寄件者: Jason Sek Hei WONG/PLAND <[REDACTED]>
已傳送: 星期五, 2026 年 2 月 20 日 下午 12:28
收件者: ip_ken <[REDACTED]>
副本: lao_fionne <[REDACTED]>; Travis Tsz Ki KWOK/PLAND <[REDACTED]>; Athena Pui Yin LAI/PLAND <[REDACTED]>; Yen PY LEUNG/PLAND <[REDACTED]>
主旨: [Departmental Comments] Planning Application No. A/YL-SK/445 - Temporary Logistics Centre and Workshop for a Period of 3 Years

DRAINAGE IMPACT ASSESSMENT & DRAINAGE PROPOSAL

**PROPOSED TEMPORARY LOGISTICS CENTRE FOR
3 YEARS AT LOT NOS. 595, 580 (PART) AND 598 (PART) IN D.D. 114
SHEK KONG, YUEN LONG, NEW TERRITORIES
DRAINAGE IMPACT ASSESSMENT AND PROPOSAL**

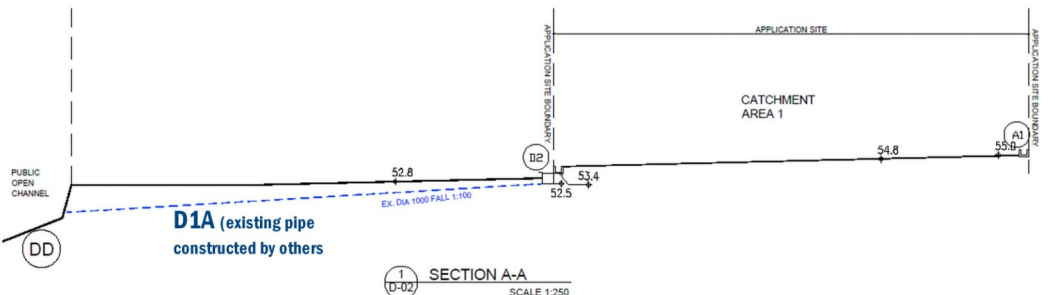
DSD's Comments for CASE – para. (e)	Response to Comments
Catchment Area 1 (Lot 595) & 2 (Lots 580 part & 598 part)	
i) application areas were formed slightly higher; to provide section to show flow of peripheral areas (before & after site formation); and drainage pipe shall consider taking care of flow of peripheral areas ii) - to show catchpit/manhole CL and IL and pipe IL. iii) - to indicate Cross sections (A-A, B-B) marks on plan; - to verify section B-B and flow levels / directions and review according to site setting. iv) - to provide connection details of 2 DN1000 pipes Note: D1A - 1000 diameter pipe to connect village channel D2 and drainage discharge of AREA 1 (Lot 595).	i) - Lot595 - refer revised section A-A, which now shows peripheral upper grounds; plan now show catchment area flow pattern; - Lot 580(part), 598 (part) – refer revised section B-B, please note that formed levels are raised, and runoff from site mainly discharge to DD via D1 (1000 mm diameter pipe); but east edge peripheral area will flow towards south to lower grounds ii) CL/IL for catpit / manhole / pipes are shown on revised Drainage Layout Plan iii) - section marks are shown on revised drainage layout plan; - levels of site, and pipes are checked and revised iv) please refer to photos of construction of D1; D1A is an existing pipe constructed by others a few years ago and construction of which has no photo record, profile section is as follows:  The diagram is a profile section labeled 'SECTION A-A' and 'SCALE 1:250'. It shows a horizontal line representing the ground profile. On the left, a 'PUBLIC OPEN CHANNEL' is shown with a manhole labeled 'DD'. A dashed line represents the 'D1A (existing pipe constructed by others)' with a slope of 'EX. DIA 1000 FALL 1:100'. The pipe starts at an elevation of 52.8 and ends at 52.5. To the right of the pipe, there is a 'CATCHMENT AREA 1' and an 'APPLICATION SITE'. The ground profile continues with elevations of 53.4, 54.8, and 55.8. A manhole labeled 'D2' is shown at the 53.4 elevation. The right boundary is labeled 'APPLICATION SITE BOUNDARY'.

Photo 1 CONDITION OF STREAM D2 (OUTSIDE SITE), AND A1B OF SITE

THE STREAM CONNECTS TO UNDERGROUND DRAIN D1A OF 1M DIAMETER

DRAIN A1, A1B, SANDTRAP ST1, AND DISCHARGE TO VILLAGE DRAIN D2

D-01A DRAINAGE LAYOUT PLAN

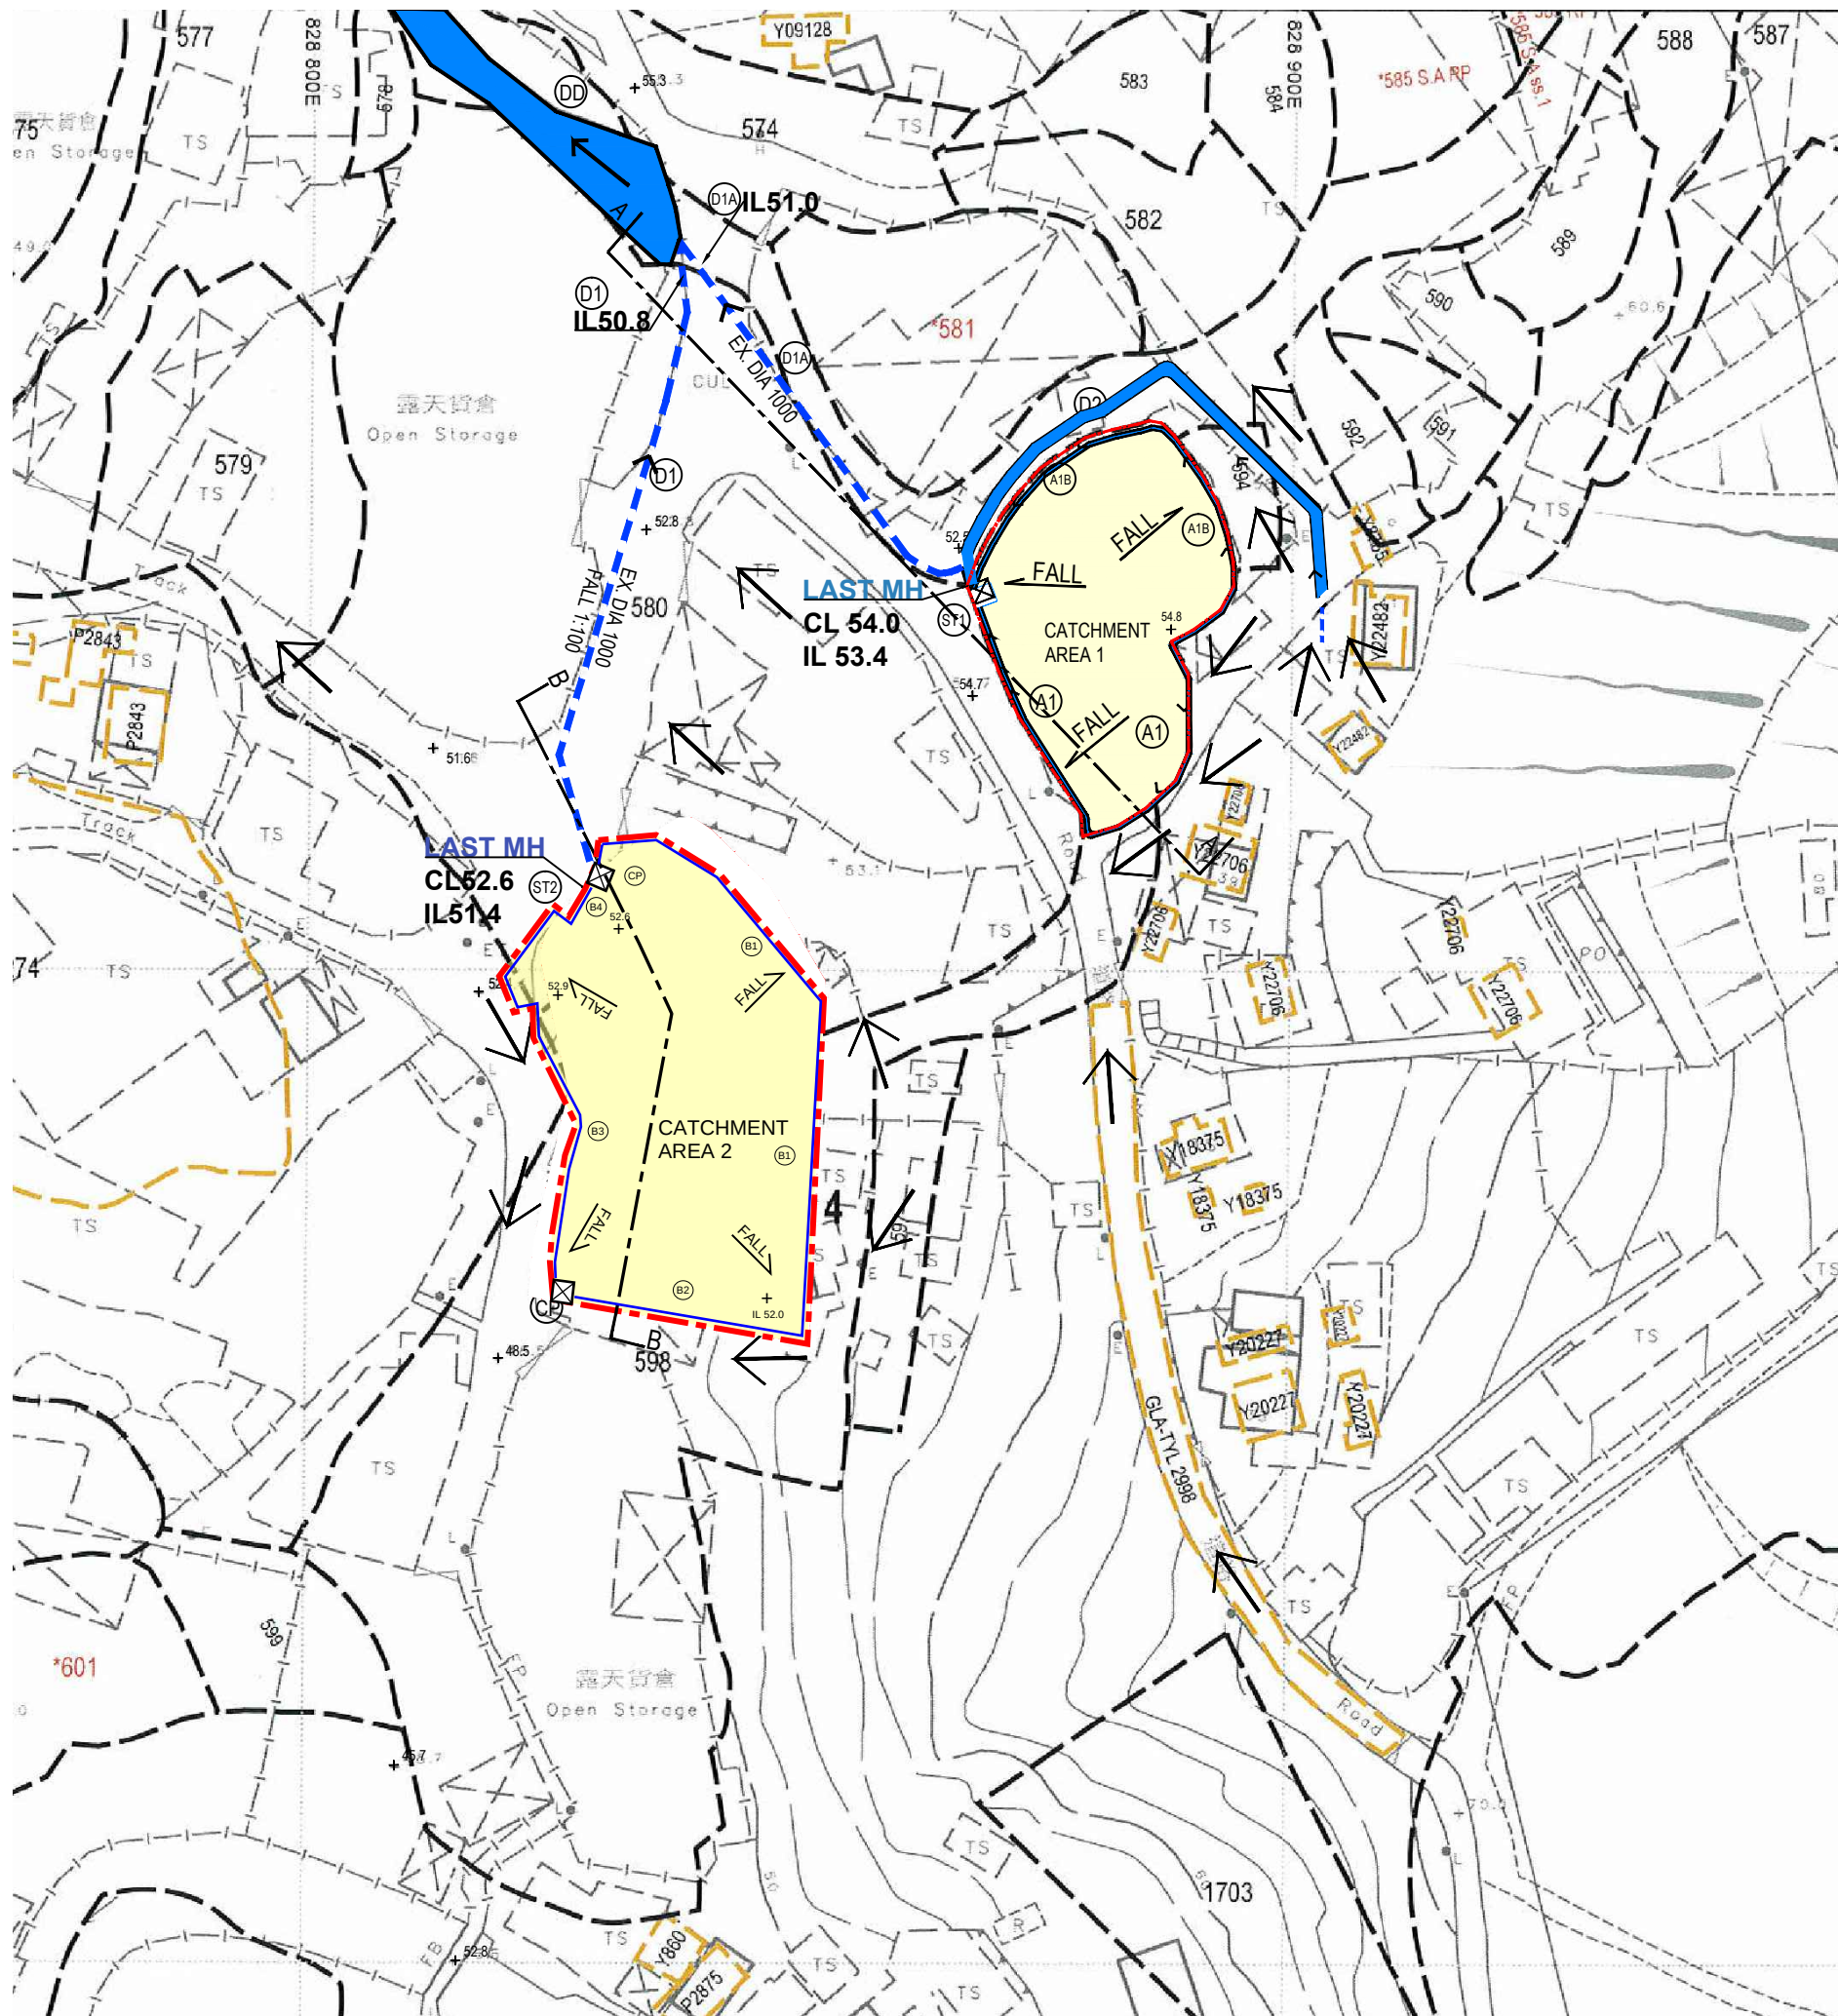
v) - to clarify sizes of B2, B3 vi) - to show flow pattern of peripheral upper ground flow	v) sizes of B2, B3 shown on drawing vi) please refer sections A-A, B-B and revised drainage layout plan showing more levels and flow pattern
--	--
